Appl. No. 10/085,061
Amdt. dated January 20, 2006
Reply to Office action of September 20, 2005
Atty. Docket No. AP1107US

Amendments to the Drawings:

Appl. No. 10/083,061
 Arndt, Dated January 20, 2006
 Reply to Office action of September 20, 2005
 Annotated Sheet Showing Changes

Fig. 1

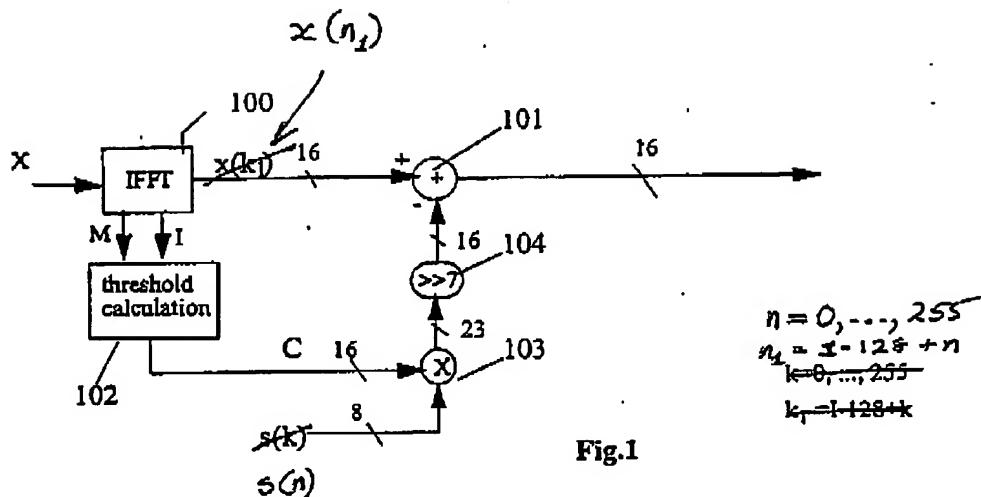
The replacement sheet of drawings includes changes to Figure 1. This sheet, which includes Figures 1 and 2, replaces the original sheet which included Figures 1 and 2. In amended Figure 1, the letter "k" has been replaced by the letter "n" (four occurrences). In Figure 2, the symbol S₁'(k) has been inserted.
